FTI-TLP4: Vehicle Coverage and Preparation Notes

FTI-TLP4 Harness Bulletin: Mis-Wired Lock Connector

Page 45 of 46 COM-BLADE-AL(DL)-TL6-EN Doc. No.: ##75162## 20210407

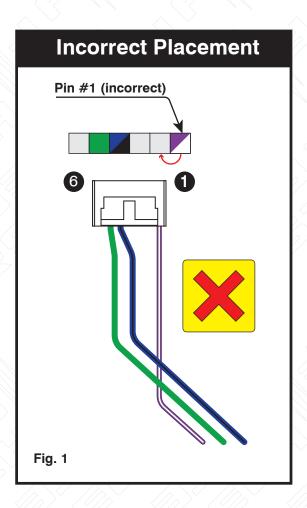
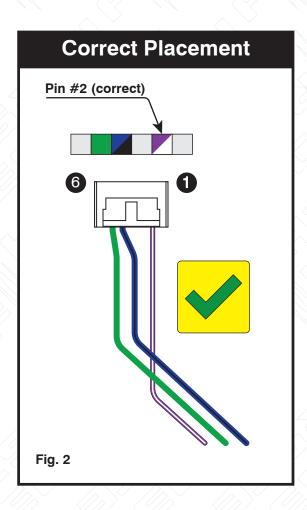
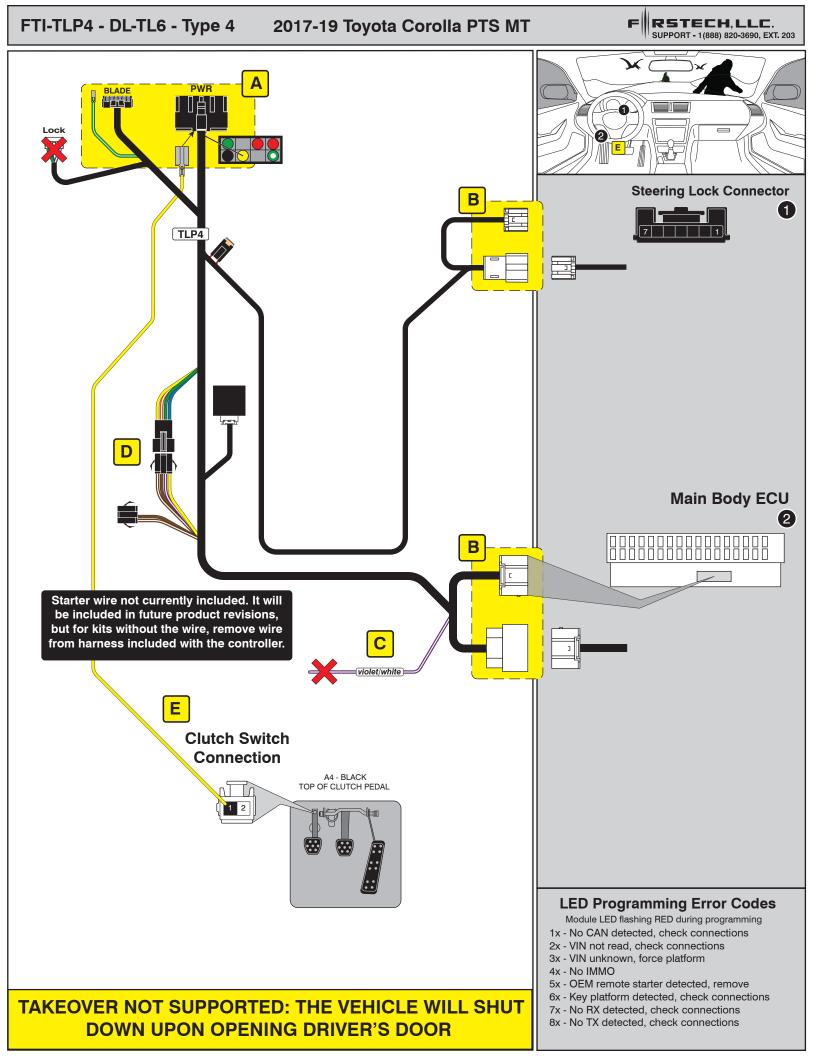
Issue: A review of the latest samples of **FTI-TLP4 T-harnesses** has revealed a misplaced trunk output wire in the 6-pin Lock Accessory Connector requiring that the wire be relocated to the correct position, to ensure safe operation when used. **Using the harness without addressing the issue will result in failed trunk/hatch control, and possible damage to the vehicle BCM.**

Correction: The harness purple/white wire in the latest production run of FTI-TLP4 harnesses has been inserted in the position normally used for the +12V power connection in the accessory harness. Before completing the installation, the installer must relocate the harness purple/white wire to the correct position, 1 space inward on the 6-pin connector, see illustrations below in Fig. 2.

To relocate the terminal, using a fine pick or Olfa type knife, depress the terminal locking barb and pull the purple/white wire from the connector housing. Once the terminal has been removed from the housing, again using the pick or knife, lift the locking barb about 1/16" (1.5 mm) and reinsert the terminal in the correct position. If upon initial examination of the harness the lock accessory connector looks like the illustration in Fig. 2, no modification is necessary, the wire is in the proper position.
